RE: Eagle Ranch Retail
9641 Eagle Ranch Rd NW
Grading and Grading Plan
Engineer's Stamp Date: 3/6/2025
Hydrology File: B13D002C

**RE: Eagle Ranch Retail
9641 Eagle Ranch Rd NW
Grading and Grading Plan
Engineer's Stamp Date: 1-21-2025
Hydrology File: B13D002C**

Based upon the information provided in your submittal received 02/06/2025, the Grading and Drainage Plan **is not** approved for Grading Permit and Paving Permit. The following comments need to be addressed for approval of the above referenced project:

C-1.0

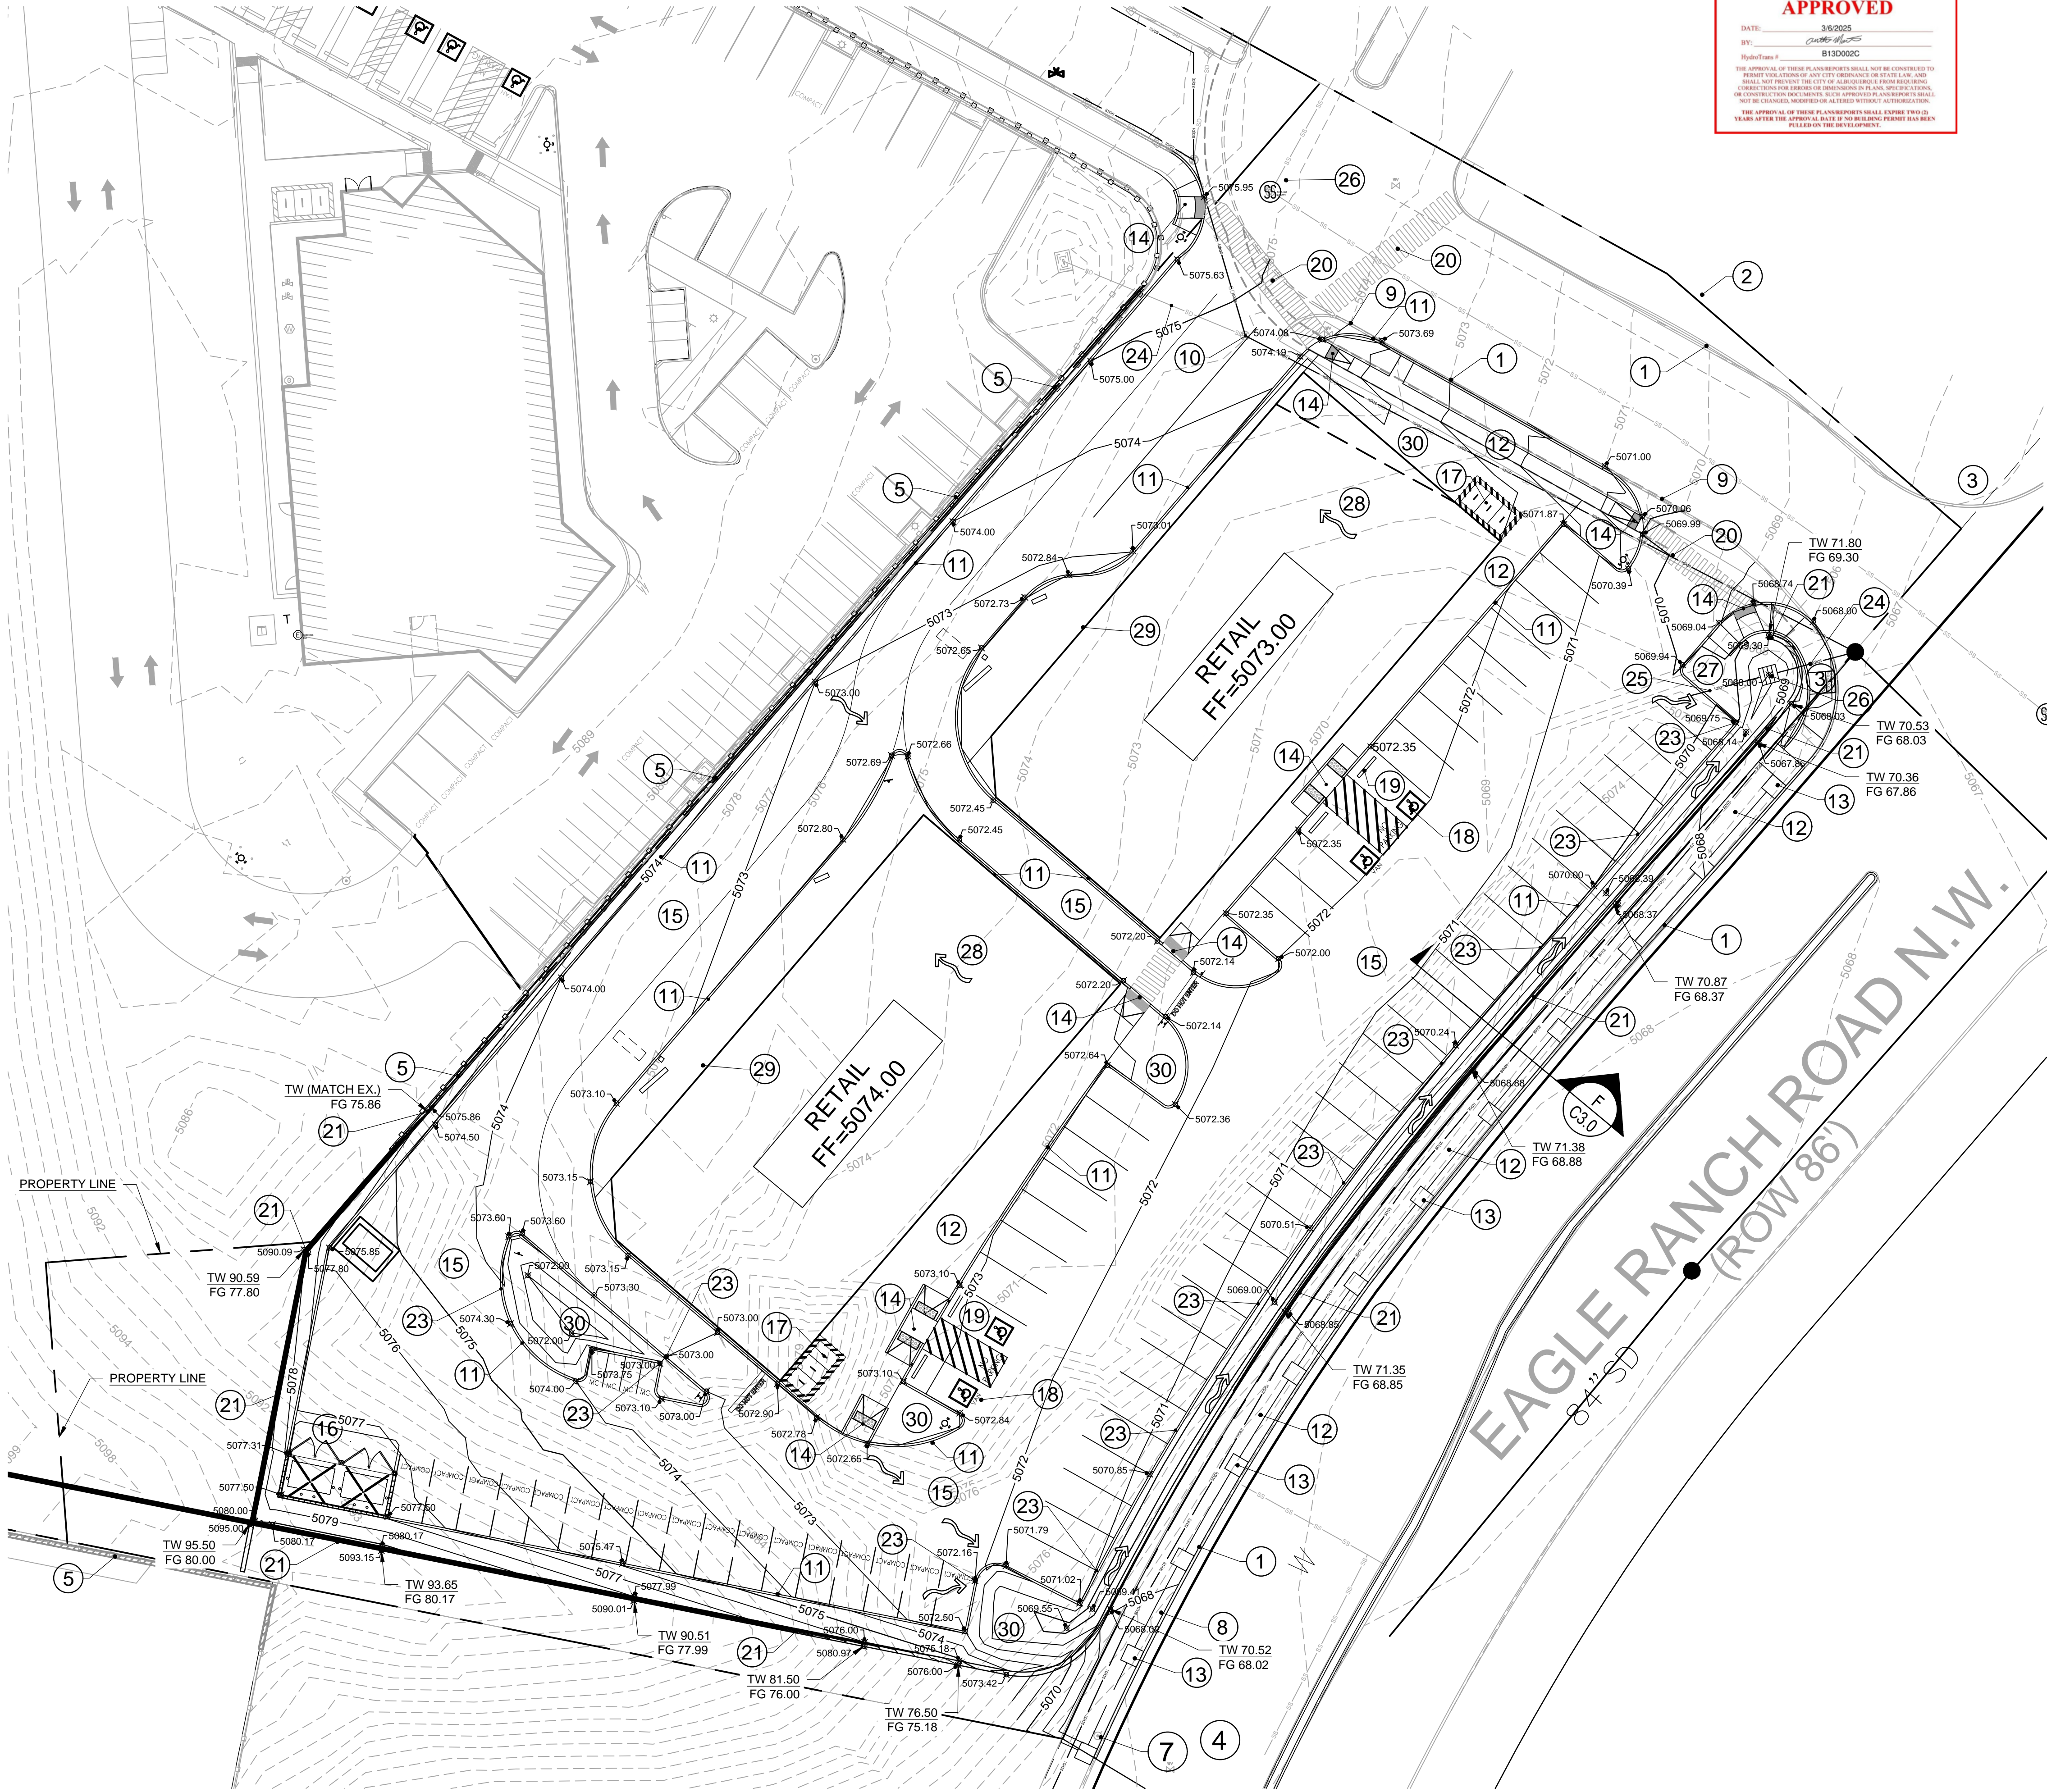
3. Show the calculation for the Storm Water Quality Volume required. Please follow the DPM Article 6-12 Stormwater Quality and Low-Impact Development for the sizing calculations. To calculate the required SWQV, multiply the impervious area draining to the BMP by 0.42 inches for new development sites. The calculations of both the required and the provided volume of each BMP must be shown on the Grading and Drainage Plan. Each BMP should be labeled on the Grading and Drainage Plan with the required SWQV and associated water surface elevation and the 100-year water surface elevation. (Concur, added requested information to revised drawing sheet C-1.0 Drainage Plan, dated 3/6/2025)

STORM WATER QUALITY CALCULATIONS
90th PERCENTILE RAINFALL = 0.42 INCHES
TOTAL IMPERVIOUS AREA OF PROPOSED DEVELOPMENT = 1.25 ACRES.
SWQV = 1.25 AC x 0.42 IN. = 0.52 AC-IN = 0.04 AC-FT.

REQUIRED SWQV = 0.04 AC-FT
PROVIDED SWQV VOLUME = 0.06 AC-FT

FIRM MAP (35001C0108G, EFFECTIVE DATE 9/26/2008)

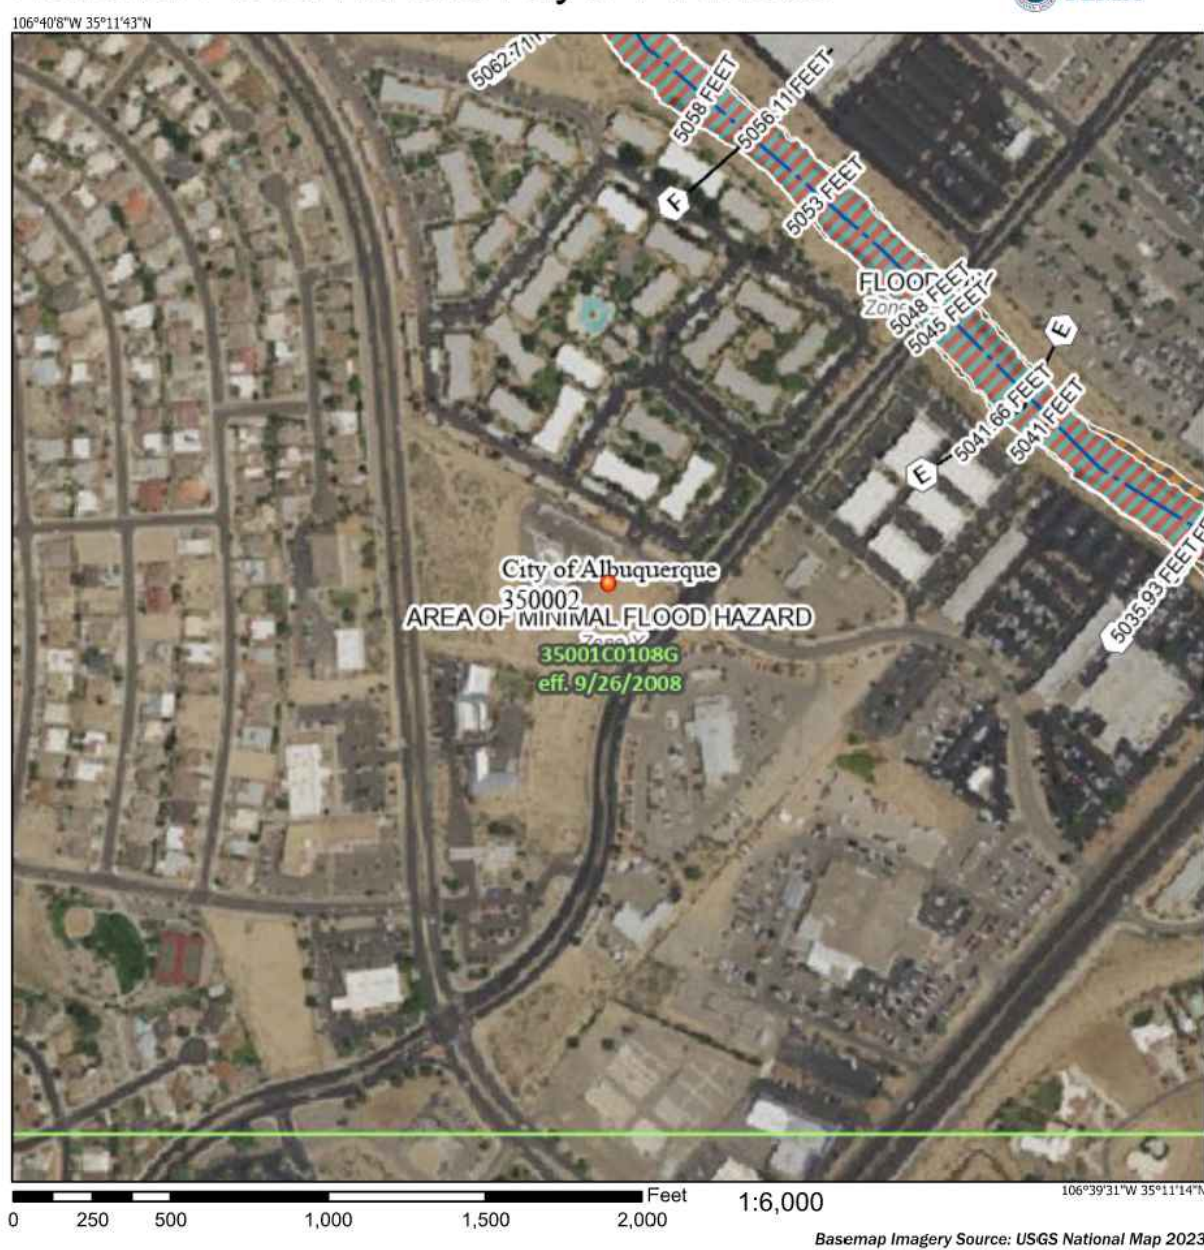
1. Please provide the FIRM Map and floodplain note with effective date.
(Concur, FIRM map provided in revised drawing sheet C-2.0, dated 3/6/2025)
2. Please provide the Benchmark information (location, description and elevation) for the survey contour information provided. (Concur, added benchmark information to revised drawing sheet C-0.1 Existing Survey, dated 3/6/2025)

FLOODPLAIN NOTE:
NO PORTION OF THIS SITE LIES WITH A FLOOD PLAIN AS DESIGNATED ON THE FEMA FLOOD INSURANCE RATE MAPS, MAP NUMBER 35001C0108G, EFFECTIVE DATE 9/26/2008.
